JOINT REGIONAL PLANNING PANEL (Sydney West Region)

JRPP No	2014SYW146
DA Number	842/2014
Local Government Area	Camden
Proposed Development	Residential subdivision of the land into 214 lots, comprising 213 residential lots and a super lot (for a potential future road connection to land to the east), demolition of existing dwelling/structures, remediation of contaminated land, and associated site works.
Street Address	51-61 St Andrews Road Leppington Lot 2126 DP 1193710 and Lot 722 DP 1192964
Applicant/Owner	Minotaur Project Management Pty Limited for Cornish Group No Two Pty Limited
Number of Submissions	Three public submissions
Regional Development Criteria (Schedule 4A of the Act)	Capital investment value (CIV) of the works = \$20,197,337. Criteria is CIV > \$20 million
List of All Relevant s79C(1)(a) Matters	<ul style="list-style-type: none"> • State Environmental Planning Policy (State and Regional Development) 2011 • State Environmental Planning Policy (Sydney Region Growth Centres) 2006 • State Environmental Planning Policy No 55 – Remediation of Land • Sydney Regional Environmental Plan No 20 – Hawkesbury-Nepean River - Deemed State Environmental Planning Policy No 20 • Camd

Figure 1: Proposed Subdivision Layout Plan (refer to Attachment 2)

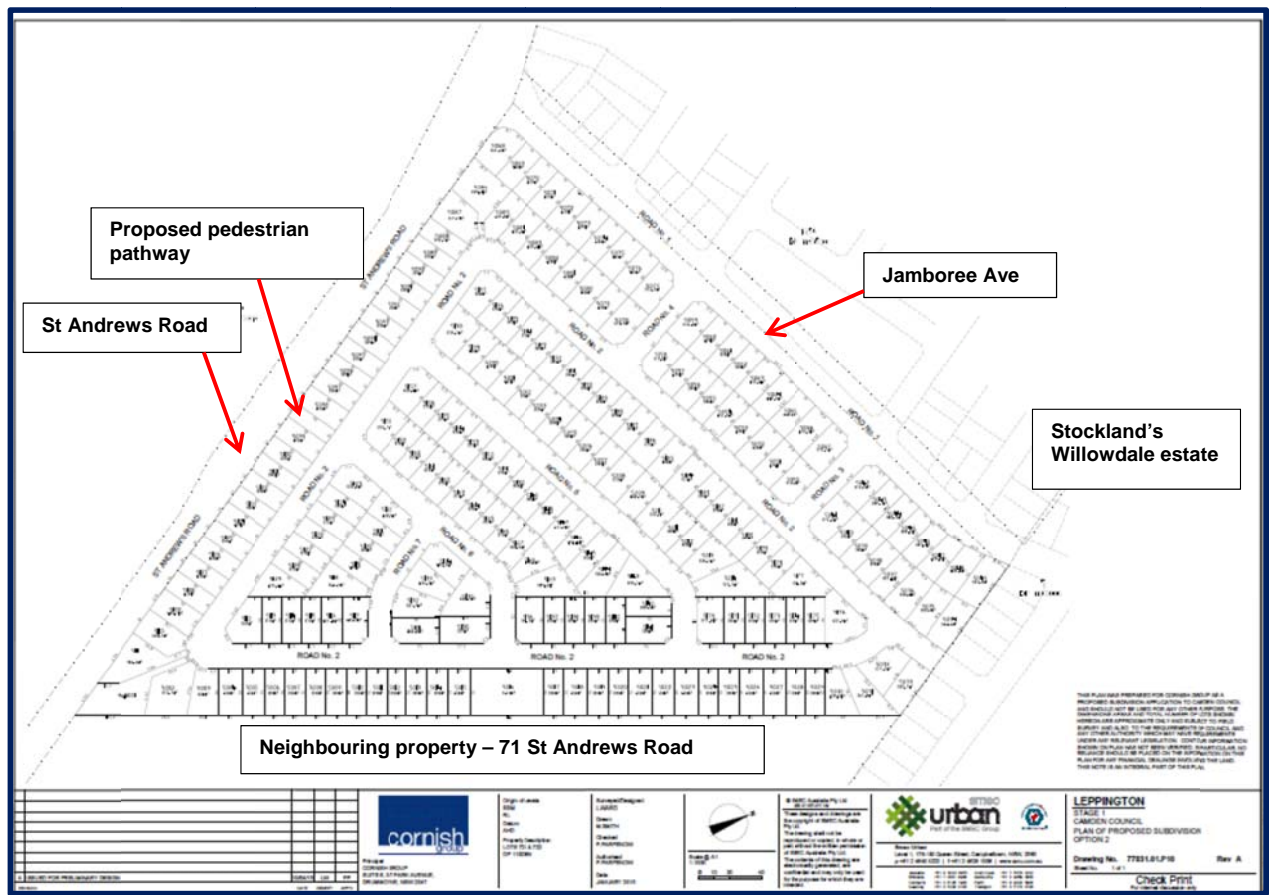
The applicant proposes variations to the Indicative Layout Plan and road locations and alignments as set out in the Camden Growth Centres Precincts Development Control Plan. A single road connection is proposed instead of a provision of a perimeter road along approximately half of the eastern site boundary. It is recommended that the ILP variations can be supported, subject to provision of a second local road linkage. The recommended deferred commencement conditions of consent require the provision of an amended subdivision layout.

Based on assessment of the DA, approval is recommended subject to the deferred commencement provisions under section 80(3) of the Act, requiring submission of a revised subdivision layout to provide for two local road linkages on the eastern site boundary, submission of an acoustic assessment in relation to potential road traffic noise impacts, and submission of details for retaining walls and fencing.

- a) Submit an amended subdivision layout and full set of revised plans, to provide for the following:
 - (i) a local road connection to 71 St Andrews Road (Lot 71 DP706546) over lot 5016, which is not time limited;

Figure 4: Comparison of ILP to proposed subdivision layout

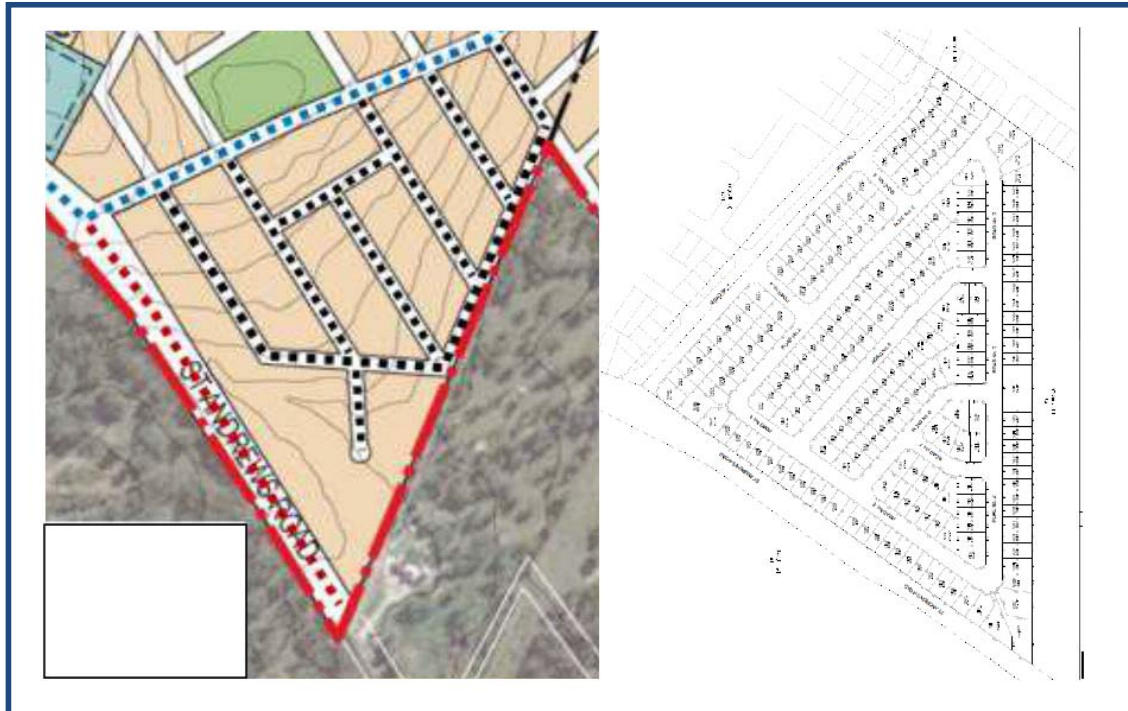
The DA proposes a subdivision and road layout which varies from the ILP and precinct Road Hierarchy figure, with the following variations:

provided for in the ILP. This means lots are more generally oriented north/south rather than generally east/west under the ILP;

- Provision of only two local road connections to Jamboree Avenue, the collector road to the north, rather than four connections as shown in the ILP;
- Provision of a single potential road connection with the adjoining property to the south east (within proposed lot 5016) instead of a provision of a perimeter road along approximately half of the boundary with the adjoining property; and
- Provision of a local road connection to the north east (connecting to approved subdivision of the land within the adjoining Stockland subdivision, DA101/2014, 21 May 2014).

A variation to the ILP and road network can be supported if a suitable level of connectivity can be retained to the neighbouring property, 71 St Andrews Road. This can be achieved with at least two road connections rather than the single proposed connection, refer to **Figure 5**.

The recommended conditions of consent deal with this matter and require the provision of an amended subdivision layout, via deferred commencement conditions, to include a second local road linkage as a continuation of Road No 5 over proposed lots 5022, 5023 & 5024.

Figure 5: Two road connections to 71 St Andrews Road

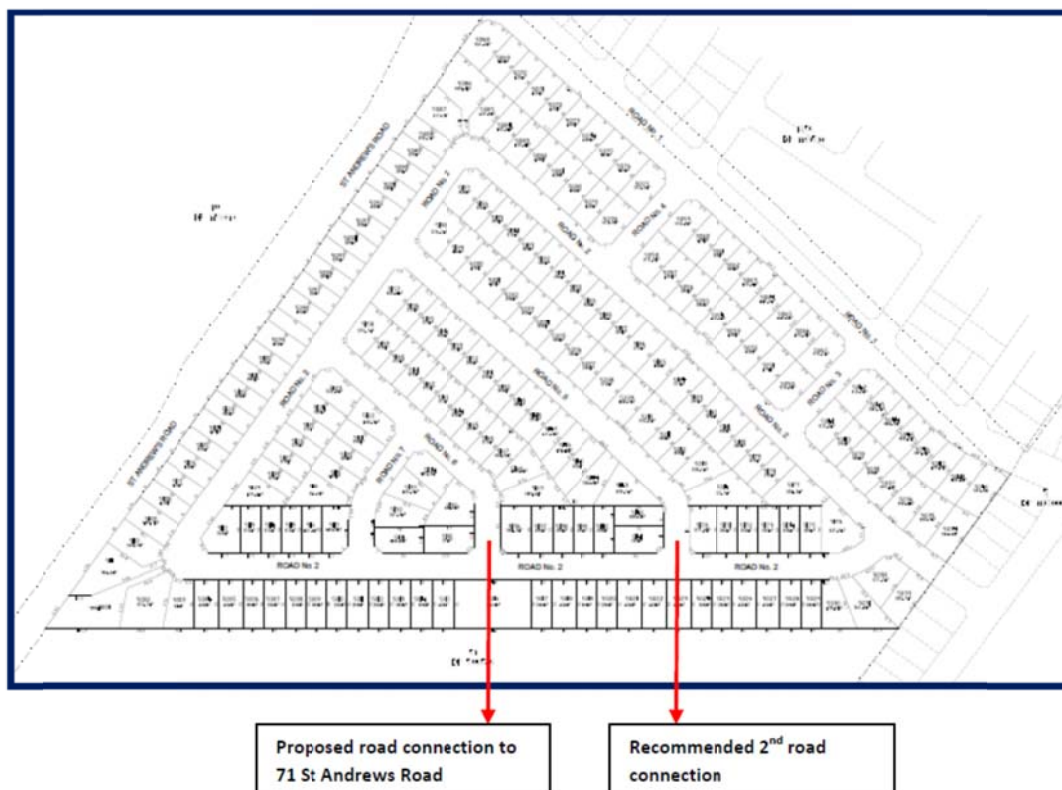
The road connections should not be limited to three years from the date of determination, as proposed by the applicant, in relation to the single connection over proposed Lot 5016. These connections can be provided as temporary public roads. Under this arrangement the temporary roads would be constructed as part of the subdivision. Any future closure of the temporary public roads would be subject to the provisions of section 39 and 40 of the Roads Act, where the original subdivider, or successor/s, can apply to become the owner of the land on which the temporary road was situated.
